Design Review Board Case #2018-0001
Carlyle Plaza Two – South Residential Building

The applicant, Alder Branch Realty Limited Partnership, LLLP; represented by JM Zell Partners, is requesting the Design Review Board’s (DRB) review and commentary on the revised design of the low-rise liner units proposed with the first phase of the Carlyle Plaza Two development.

Figure 5 – Low Rise Building Elevations Comparison

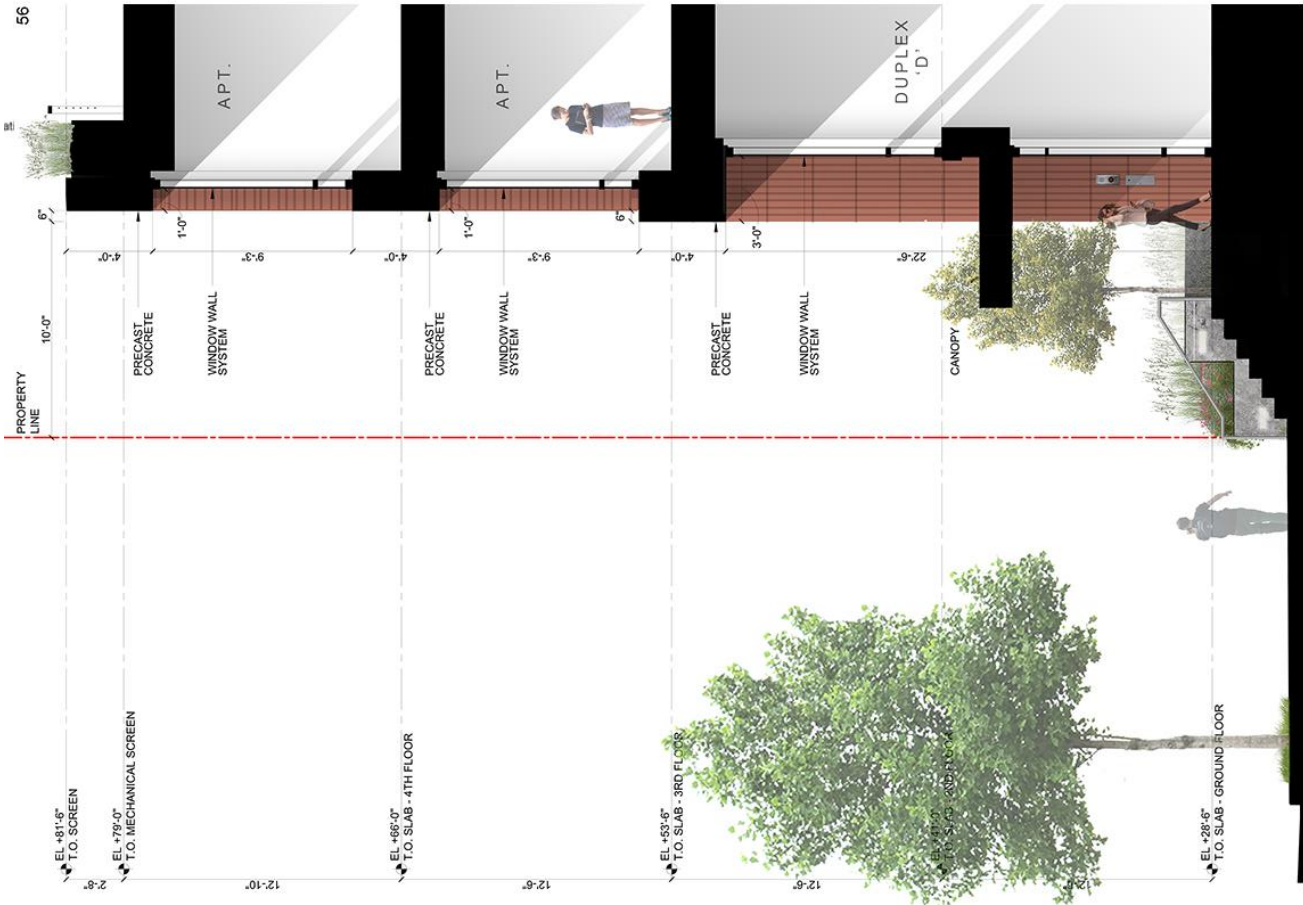
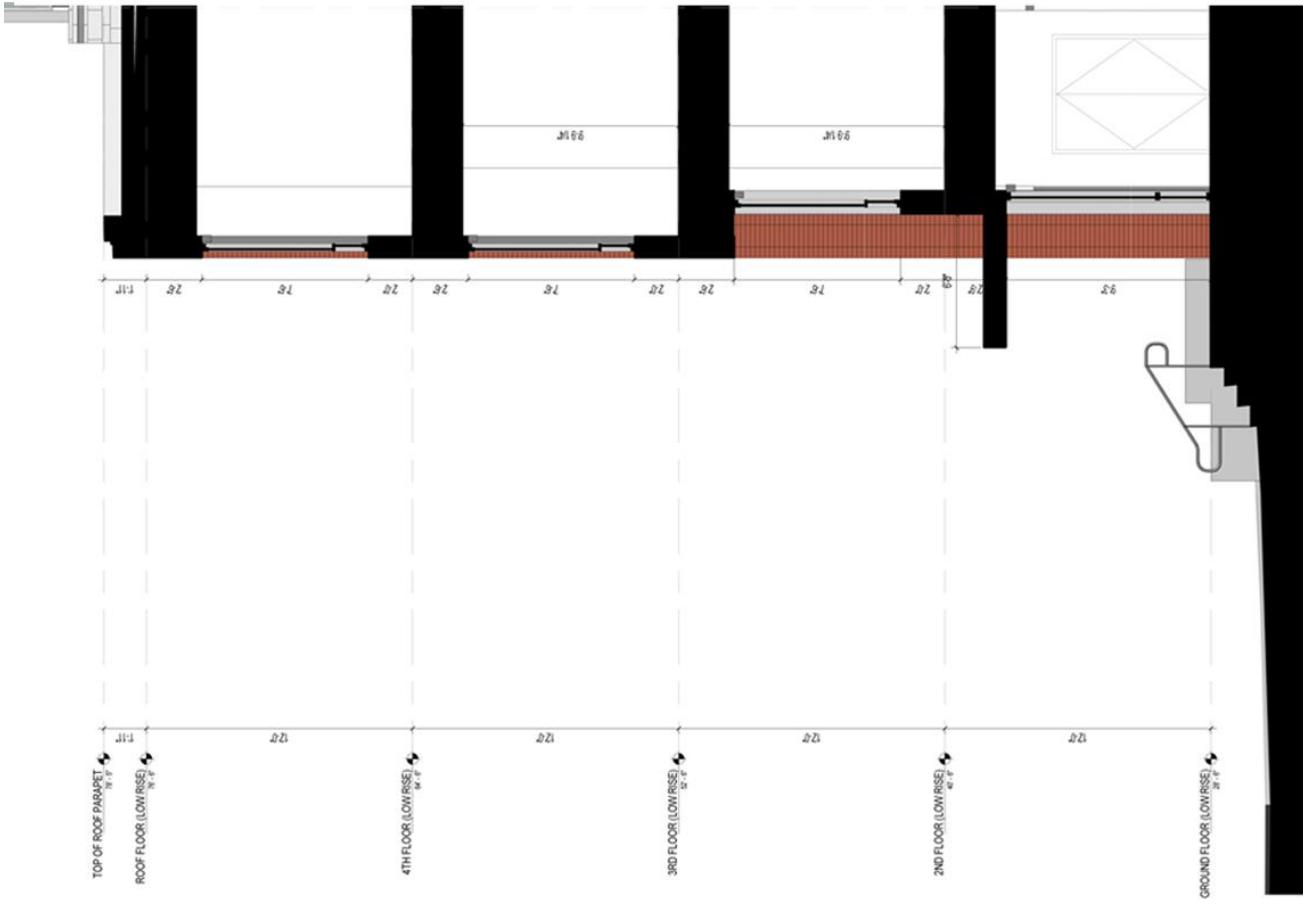
The total building height measured from the finished floor of the duplex units to the main roof was 50'-6" at the time of the DRB's approval in July 2016. Now, the proposed building height is 48 feet when measured from the same points. Although a 2 and one-half foot difference in height may seem insignificant, it is apparent that this reduced height has negative effects on the proportions of the west building façade and the overall relationship of the low-rise building to the South Residential Tower (see Figure 5).

Further, the top of the low-rise liner building aligned with the top of the 5th floor glazing on the South Residential Tower in the approved design. This was a successful relationship that reinforced the clean lines and geometry of the overall project and created a smooth transition of the South Tower to the ground. Now, the top of the low-rise liner building is noticeably/substantially below the top of the South Tower's 5th floor glazing, creating a somewhat broken transition between the two buildings. Although a 2-foot increase to the height of the 5th floor was approved by the Board in March 2017, the

While the proposed method of screening the bulkhead is not shown in this submission, it is evident (see Figure 5) that the bulkhead as shown is not integrated into the overall architectural expression and materials palette of the building which is a requirement of the Eisenhower East and Carlyle Plaza Two Design Guidelines.

5. Provide a solution that aligns the top elevation of the low-rise liner building with the top of the South Residential Tower's 5th floor glazing. Subsequently, revise the shape of the single and double height glazing on the liner units to be in better proportion within the overall façade. These goals could be achieved by adding incrementally to the floor-to-floor heights in the building.

6. Per the Eisenhower East and Carlyle Plaza Two Design Guidelines, provide a solution that screens the elevator bulkhead in a way that is integrated into the overall architectural expression and materials palette of the building.

Figure 1-Low Rise Duplex Entry

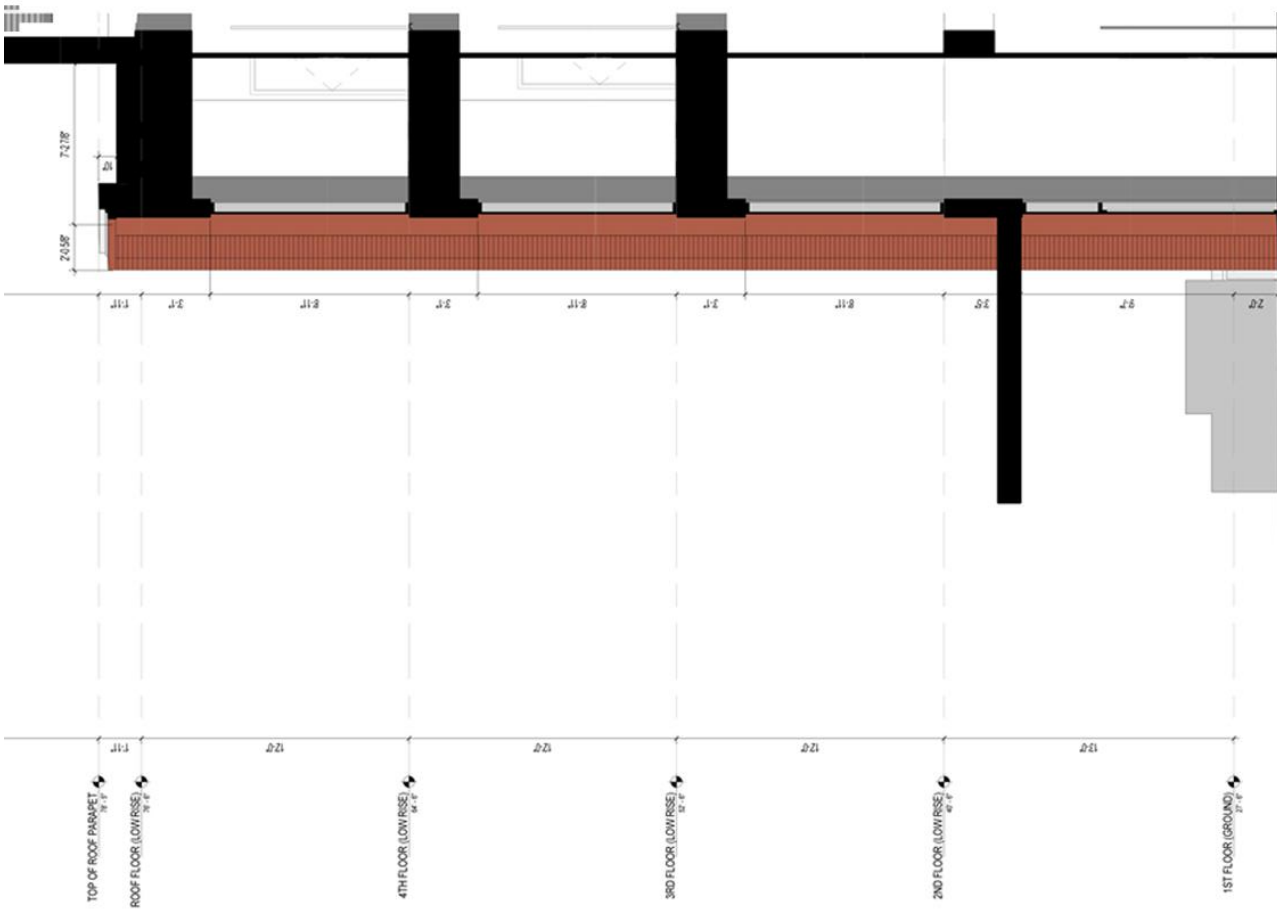
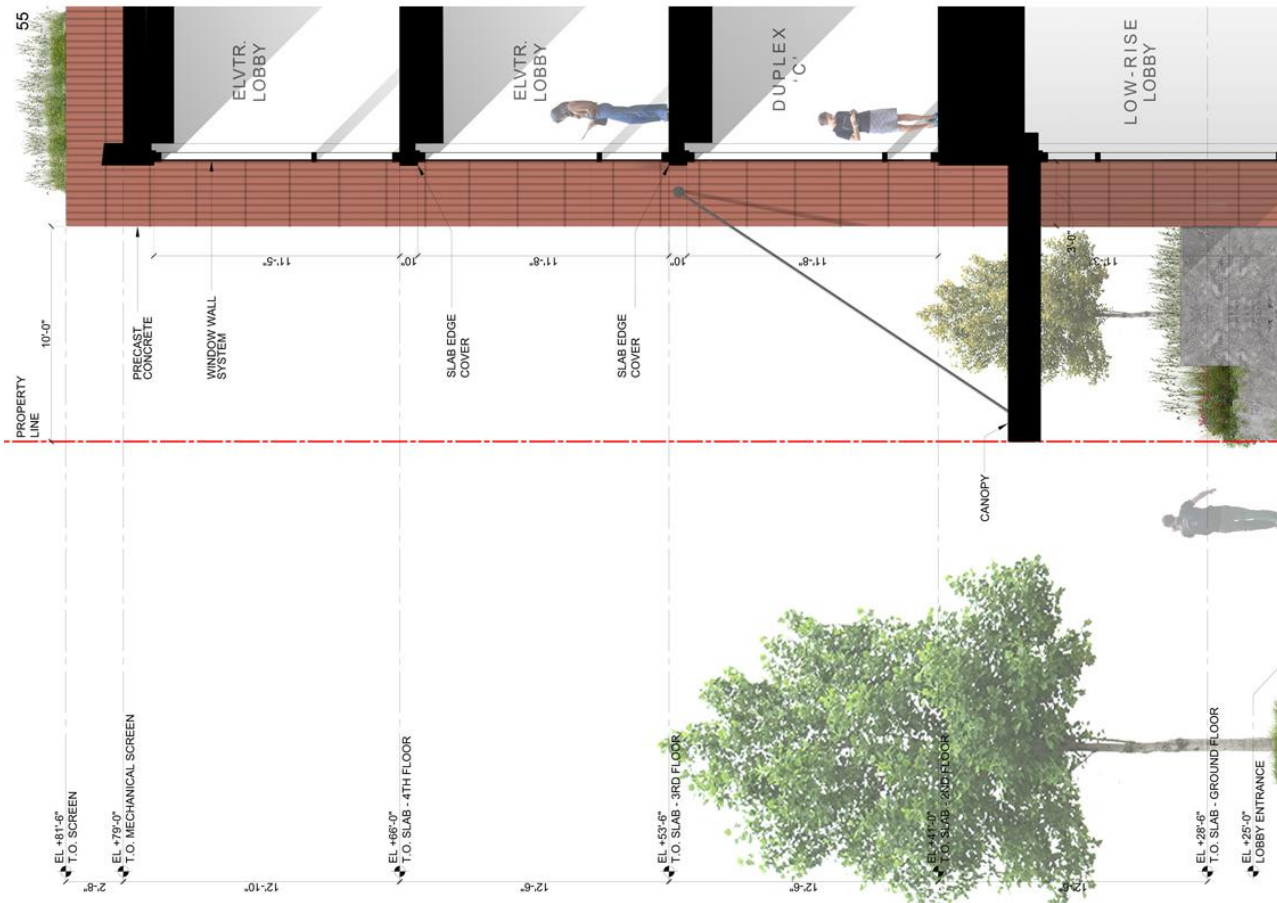
As represented in Figure 1, a 6-inch depth between the front and back planes was proposed in the concept presented to the DRB in July 2016. At that time, the Board approved of the design with the condition that this depth be increased to 12 to 16 inches between the front and back planes. The currently proposed design appears to measure to a depth of approximately 2-inches, which is significantly less than the depth stipulated in the DRB's approval.

1. Maximize the depth between the front and back planes of the west façade to comply with the DRB's condition of approval for a 12- to 16-inch depth between planes.

Figure 2-Low Rise Lobby

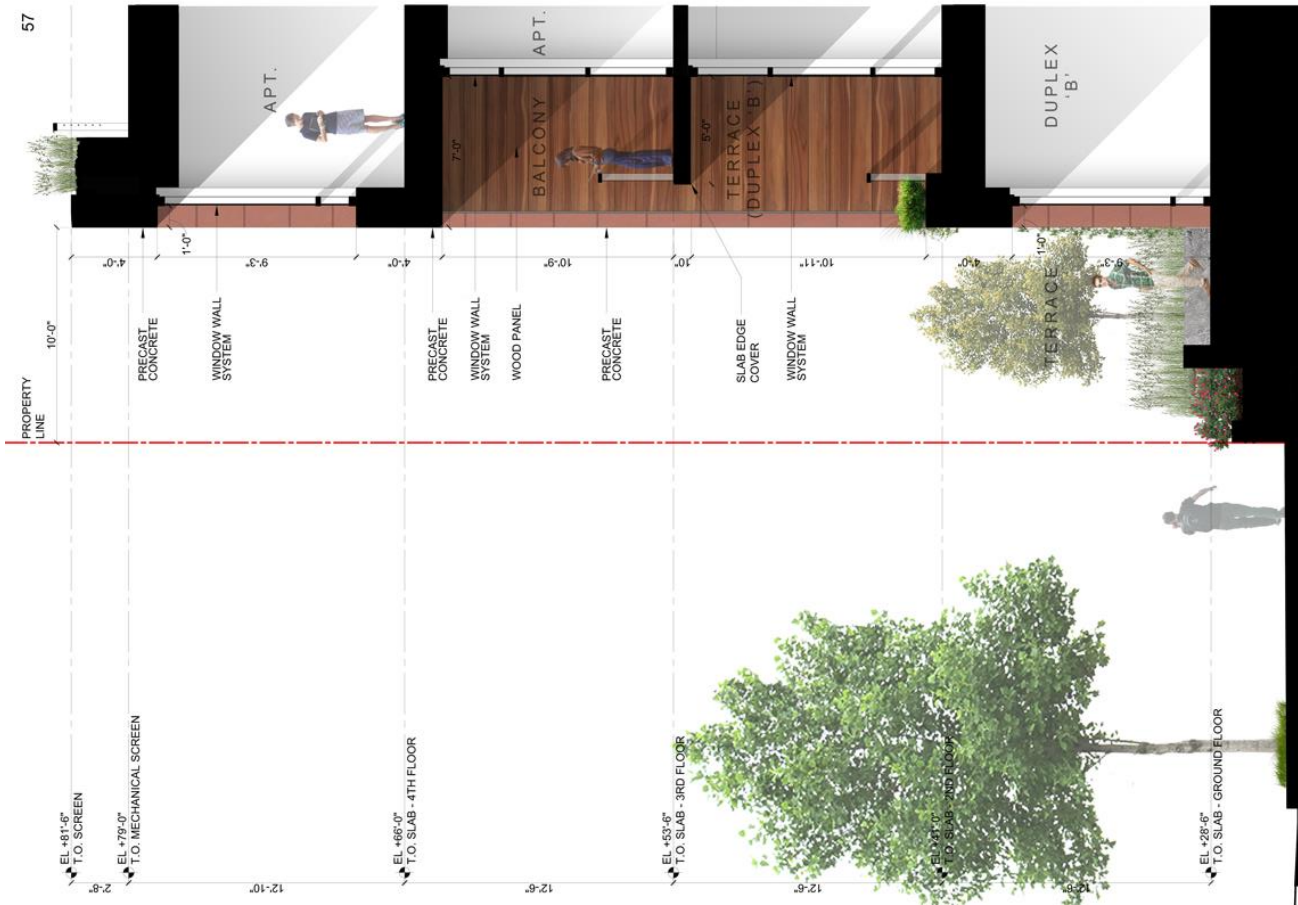
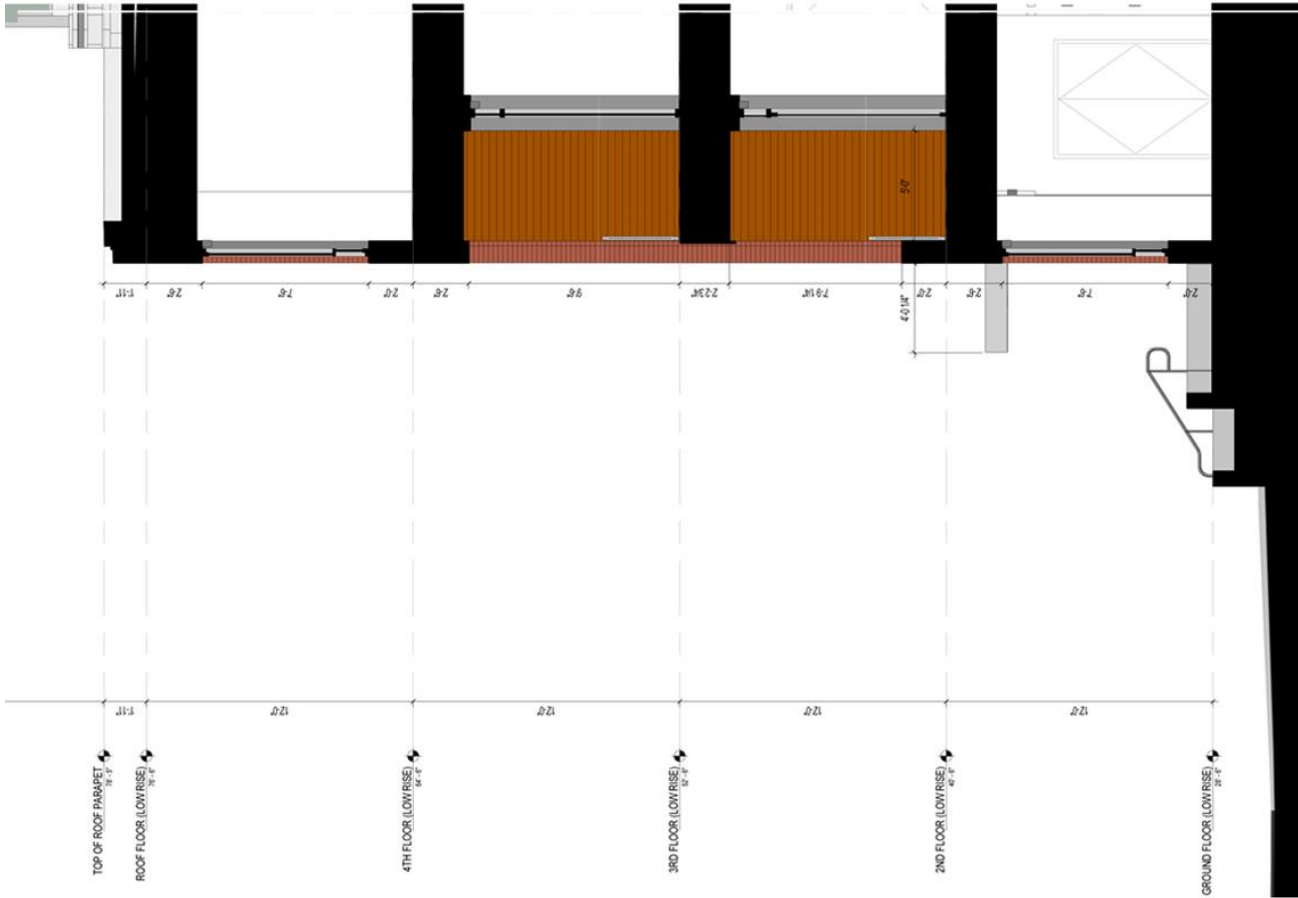
Another significant contributor to a sense of depth on the west building façade is the distance between the face of the window wall system and the face of the masonry. The originally approved design, as represented in Figure 2, illustrates a dimension of 3 feet between the face of the masonry and the window wall at the lobby entrance. Additionally, Figures 3 and 4 illustrate a distance of 1 foot between the façade masonry and the typical window wall at the duplex and loft units in the approved design.

The current design proposes approximately 2 feet between the face of the window wall of the lobby and the face of the masonry. Additionally, the distance between the face of the masonry and the window wall at the duplex and loft units is minimal, appearing to measure between 2 and 3 inches.

3. Increase the depth between the face of the window wall system and the face of the façade masonry to conform with the approved design.
4. Increase the depth between the edge of the balconies and the face of the façade masonry.

Figure 3 – Duplex Balcony 1

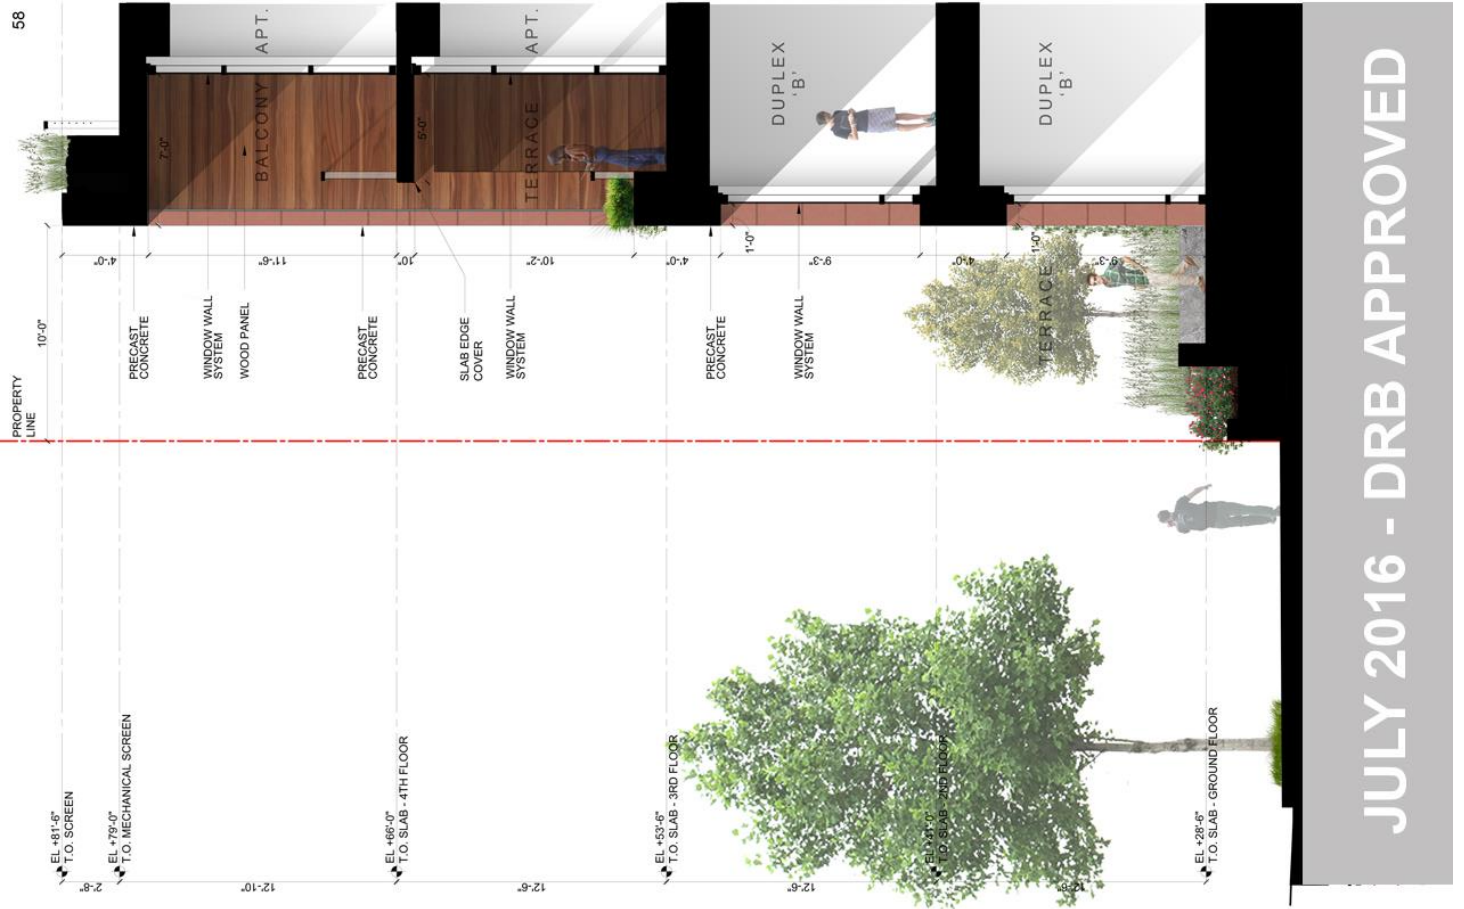
The third significant change to the depth of the west building façade is the reduced distance between the edge of the balconies and the face of the masonry. The approved design, as shown in Figures 3 and 4, proposed 2 feet of depth between these building elements. Planters were proposed within this setback at some of the residential units which further enhanced the complexity and texture of the façade, and helped to tie the low-rise façade visually to the terraced private yards below.

The current design provides approximately 6- to 8-inches between the edge of the balconies and the face of the masonry. Additionally, the approved planters had provided both relief and interest to the façade, but have been removed from the current proposal, resulting in a very different feel to the quality of the architecture. The overall result is a

Figure 4 – Duplex Balcony 2

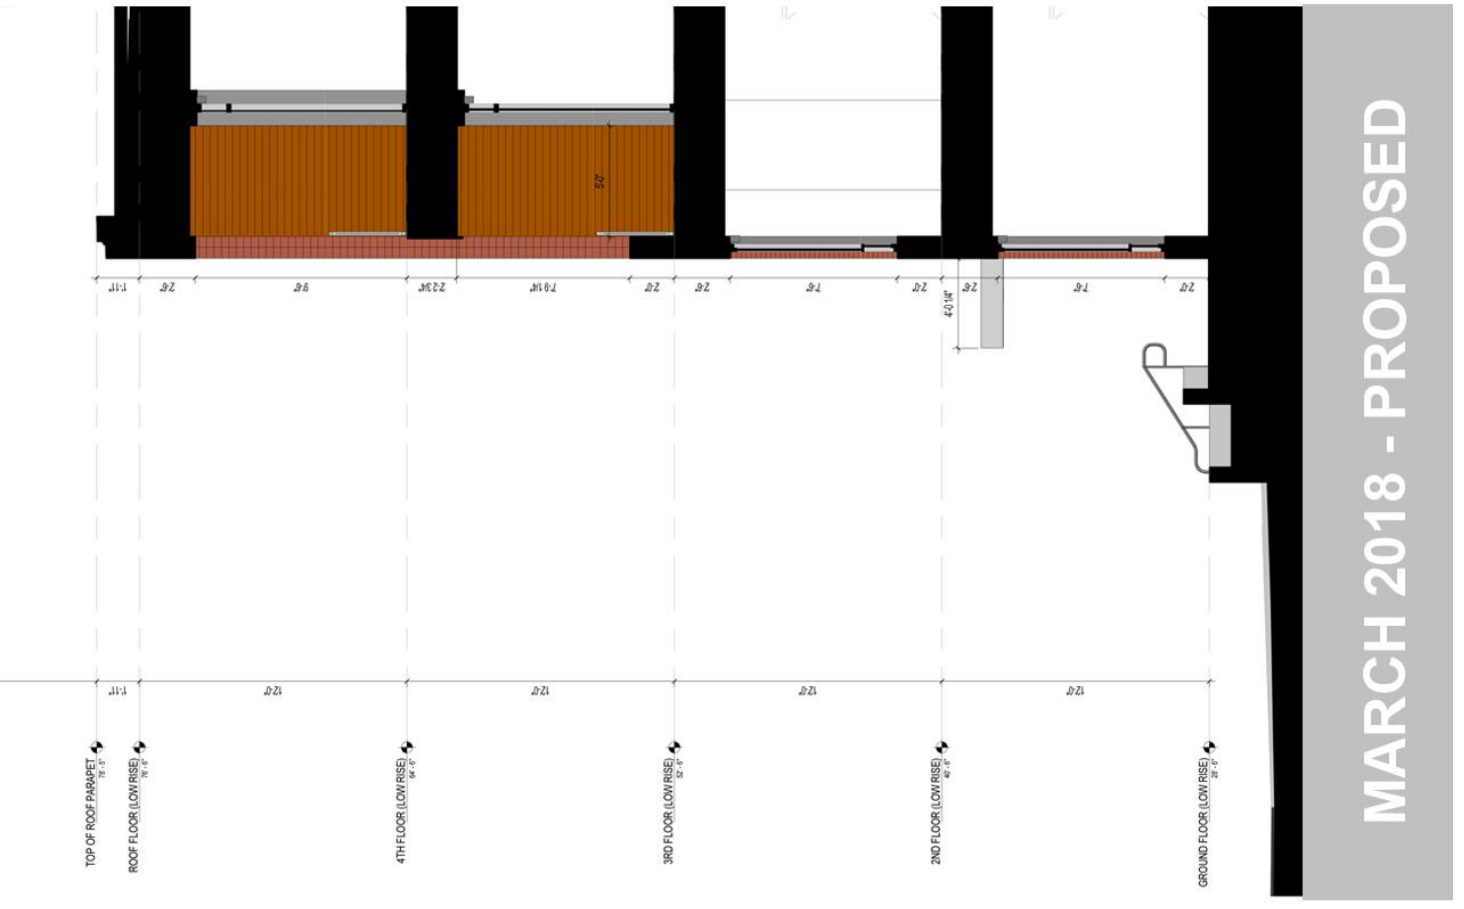
As mentioned above, the approved design incorporated planters into the 2-foot setback between the balconies and the façade masonry, as well as at the top of the building. These planters provided texture, depth, and enhanced interest to the façade in addition to screening at the roof level. Elimination of this feature also diminishes the original intent of the liner units as a garden-like residence.
